PLANNING & ZONING COMMISSION STAFF REPORT

Public Hearing Date:	July 22, 2020
Subject:	Case No. SIT-2020-0048
Owners/Applicants:	Rick Brenner, Property Owner/Paul Mifsud, Applicant
Case Manager:	Ryan Foster, AICP, Principal Planner

Case No. SIT-2020-0048:

IDRC CONDITIONS & COMMENTS: 557 Oppenheimer, June 25, 2020

Exhibit B

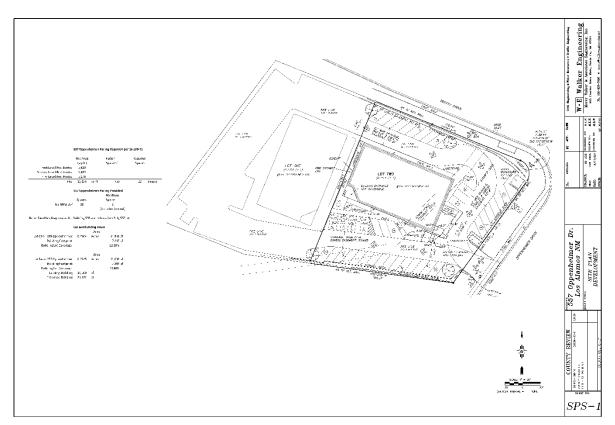
Indicate on the site plan whether the traffic circulation is one-way and provide evidence of an access agreement around 557 and 555 Oppenheimer. If two-way circulation is proposed, circulation and parking lot design standards must be met.

- 1. <u>Per Planning Division</u>: Provide parking calculations for the proposed ground floor residential use (the site plan currently has the parking calculations for commercial on the ground floor) on the site plan sheet.
- 2. <u>Per Planning Division</u>: Provide a current signed parking and access agreement since 555 and 557 Oppenheimer are sharing parking and access.
- 3. <u>Per Building Division:</u> Request all floor plans with the residential units identified.
- 4. <u>Per Department of Public Utilities:</u> As part of the building permit review the applicant must provide a revised electric load and gas load that reflects the final configuration of the building after the modifications. We will need this to evaluate if the existing gas and electric metering and service are adequate or will need modification.

Ingress and egress to the property remains unchanged, with one-way traffic circulation around 557 and 555 Oppenheimer Dr as indicated on the site plan.

A current signed parking agreement is no longer required, the applicant indicated that parking spaces will not be shared.

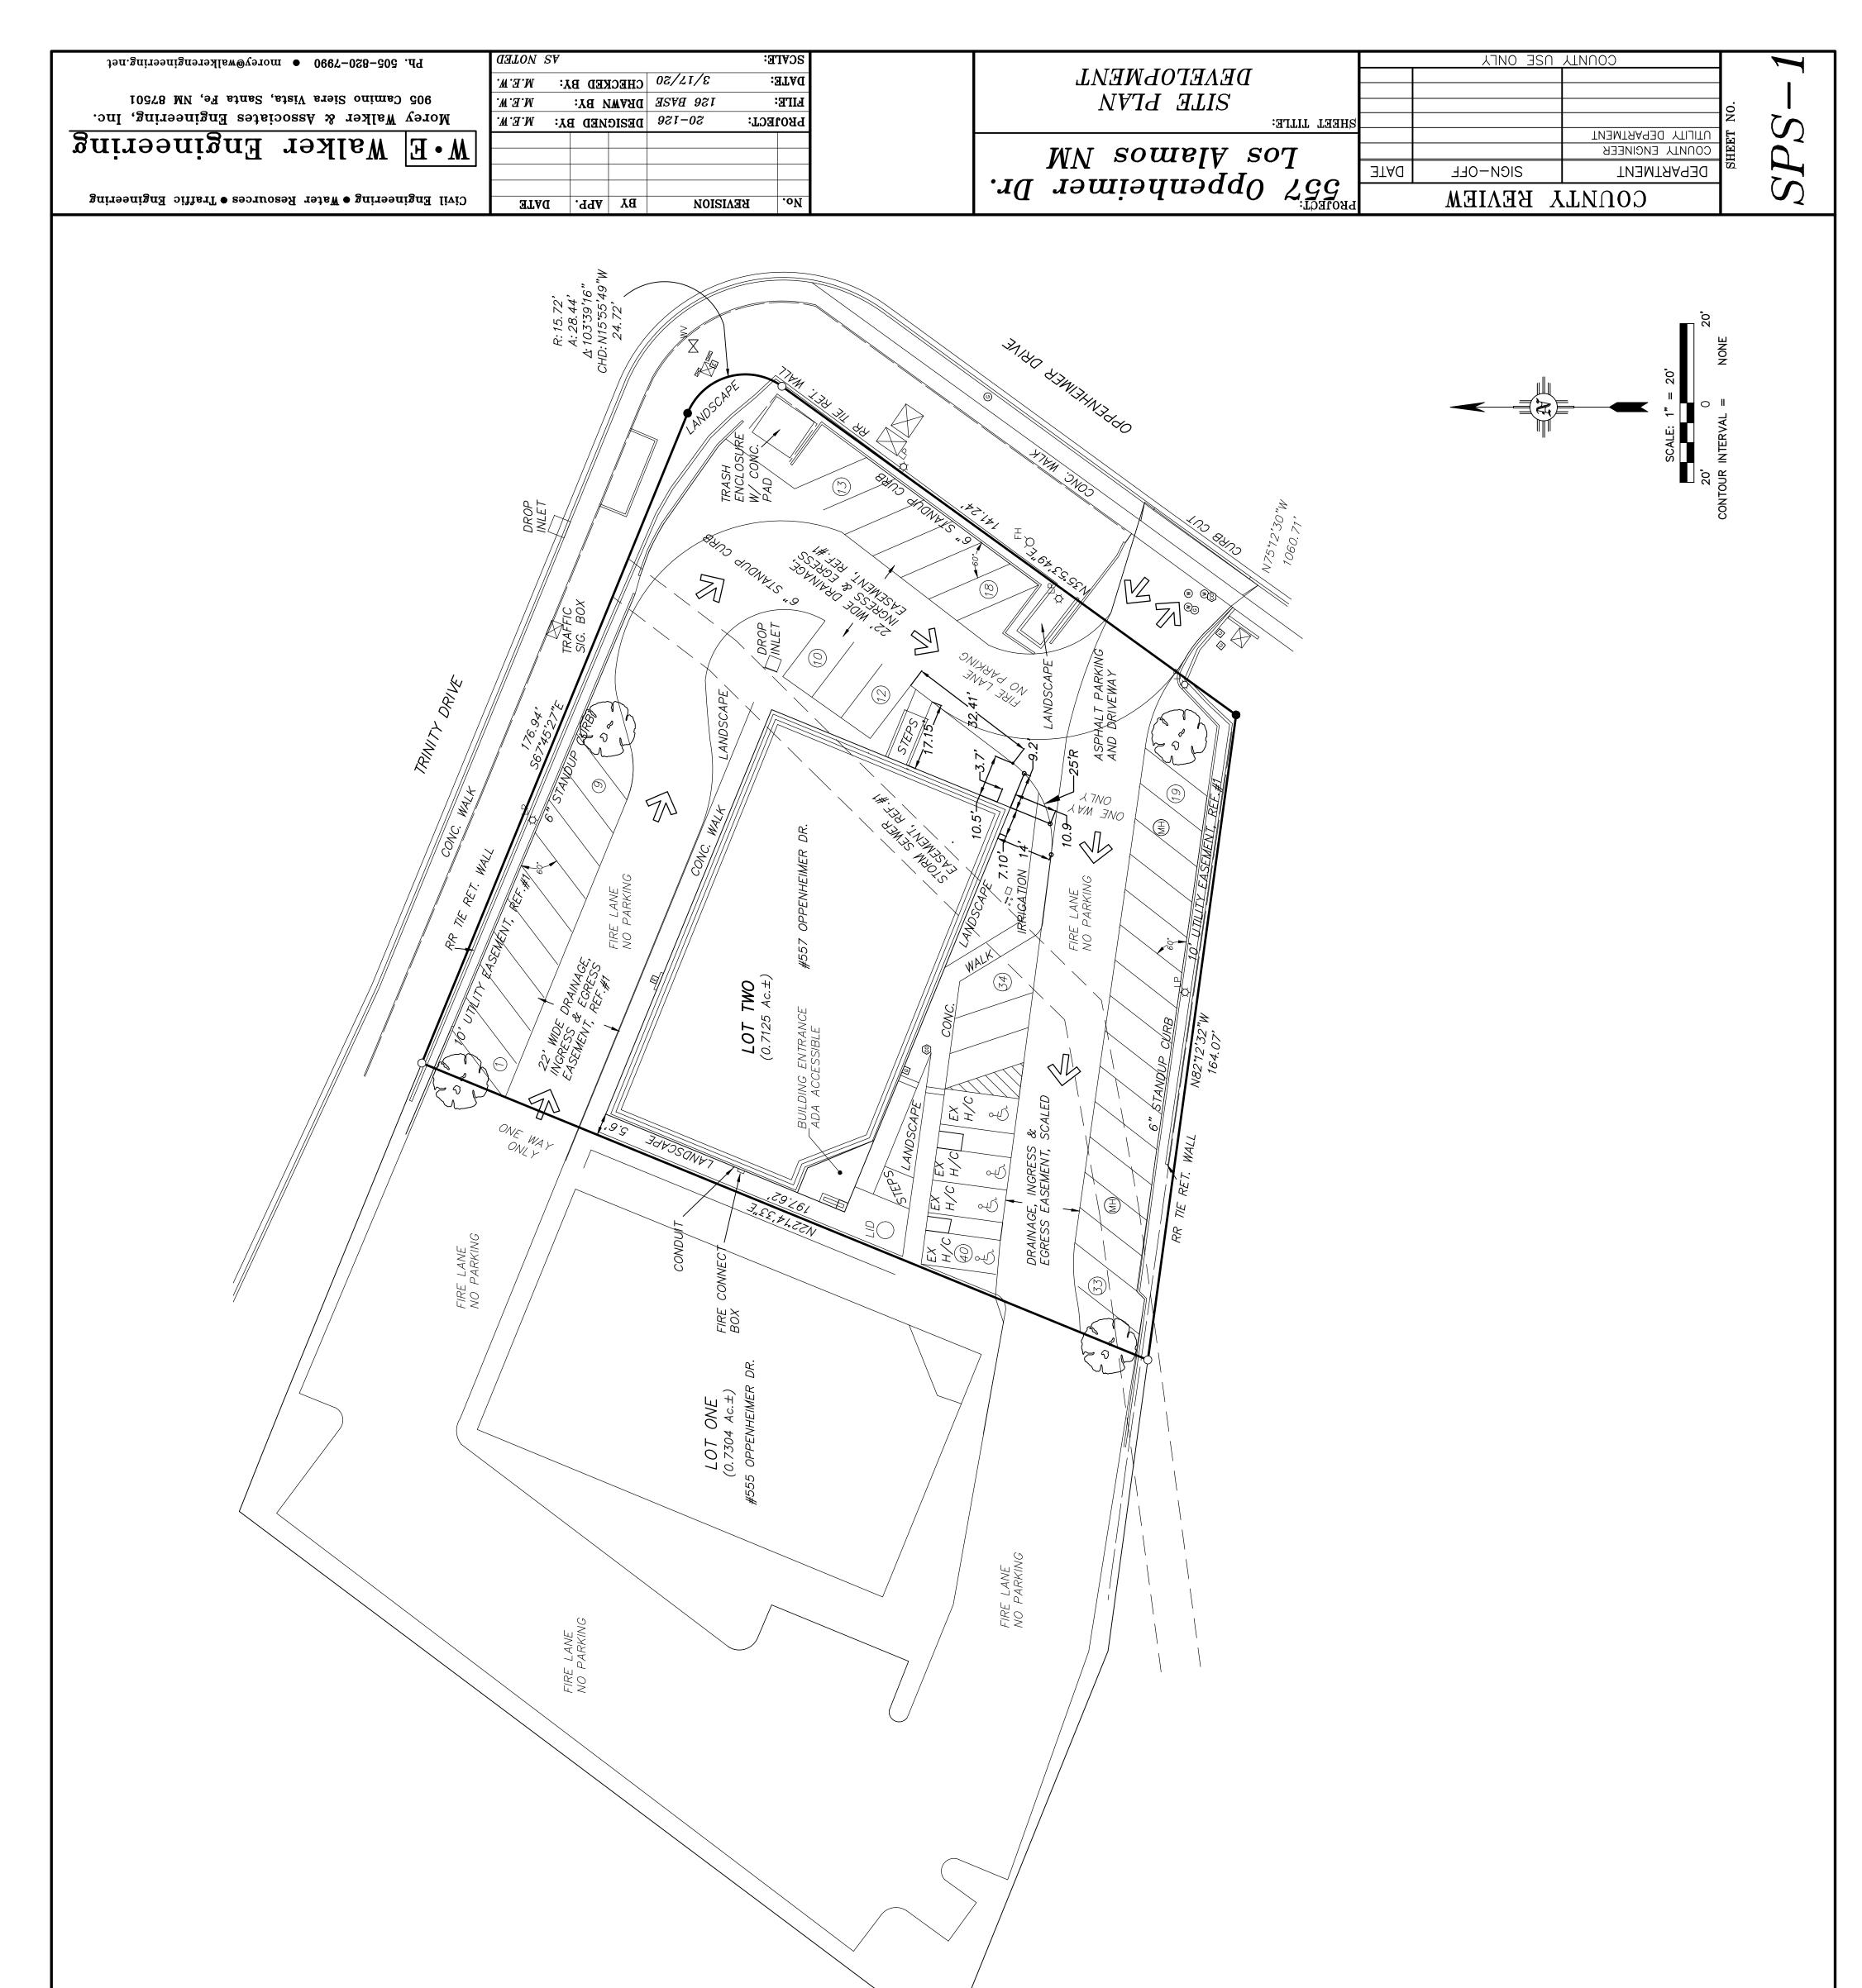
Indicate on the site plan whether the traffic circulation is one-way and provide evidence of an access agreement around 557 and 555 Oppenheimer. If two-way circulation is proposed, circulation and parking lot design standards must be met.

Provide parking calculations for the proposed ground floor residential use (the site plan currently has the parking calculations for commercial on the ground floor) on the site plan sheet.

Provide a current signed parking and access agreement since 555 and 557 Oppenheimer are sharing parking and access.

557 OPPENHEIMER BUILDING FLOOR PLAN

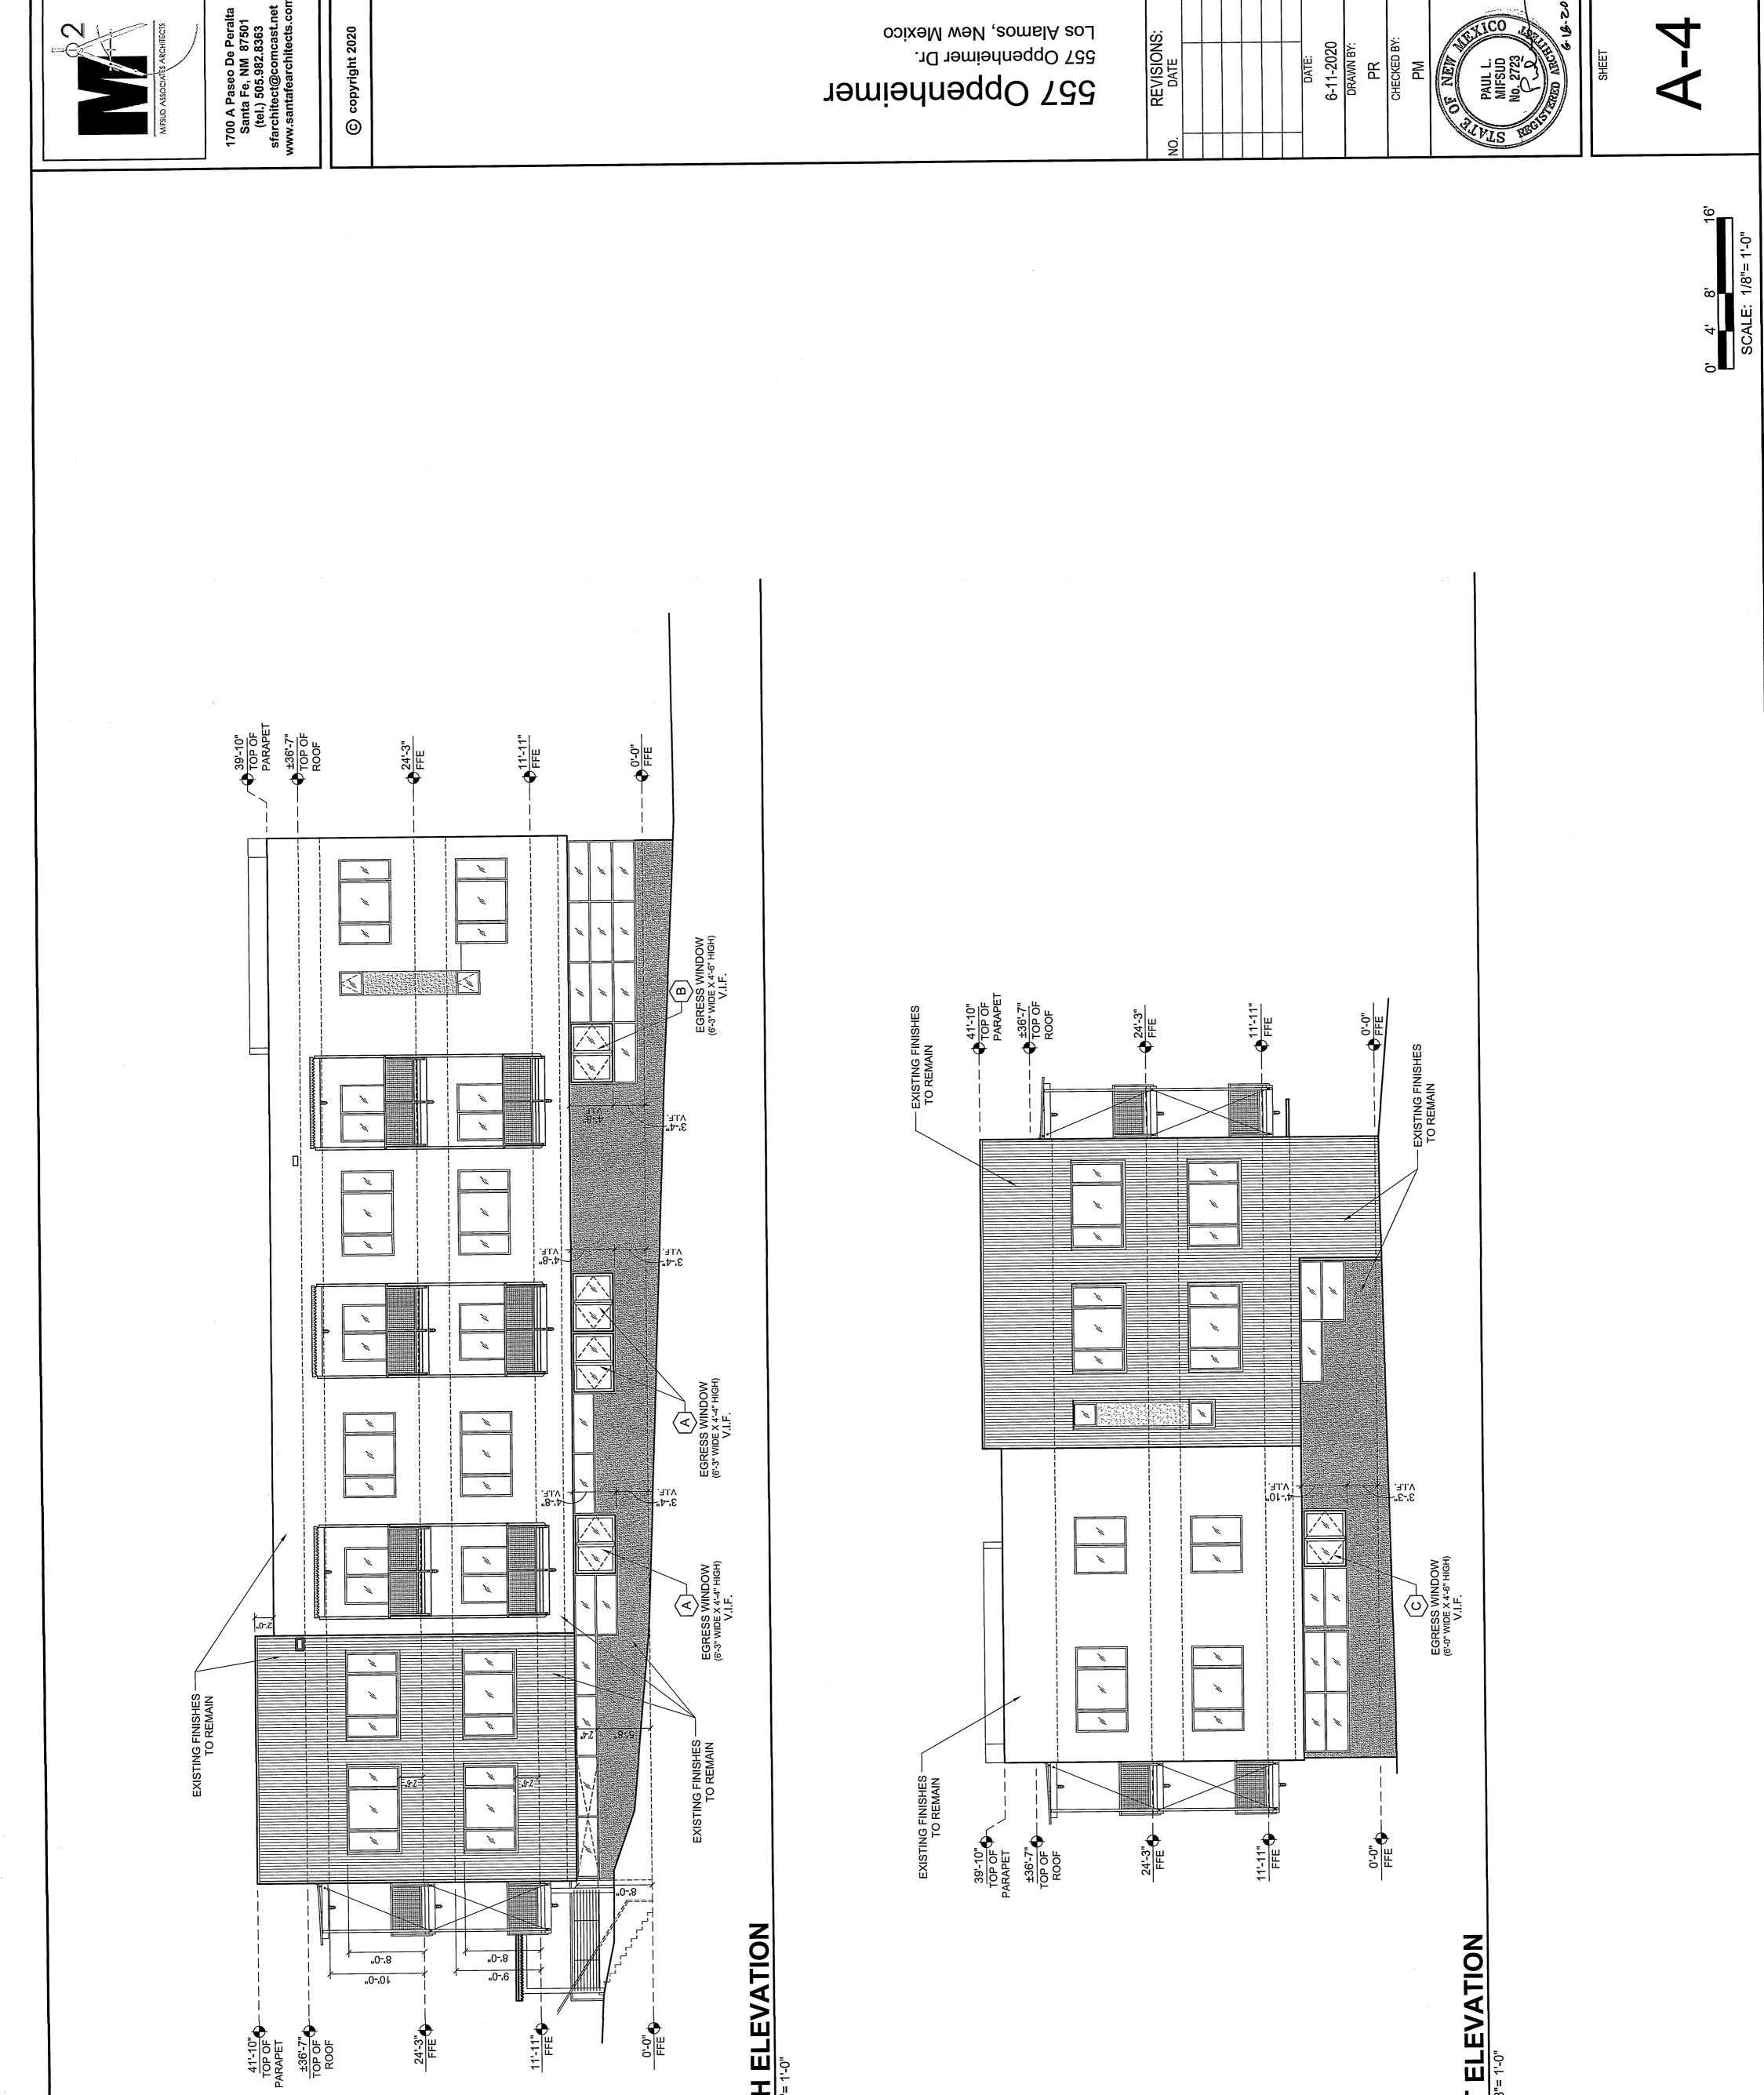
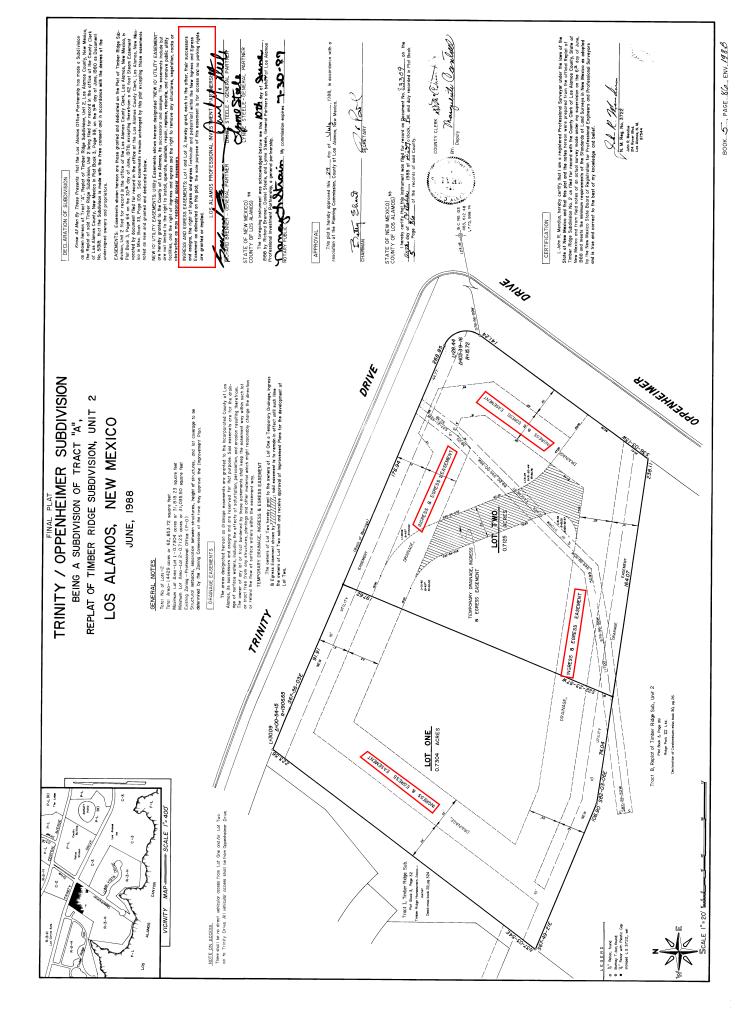
Request all floor plans with the residential units identified.
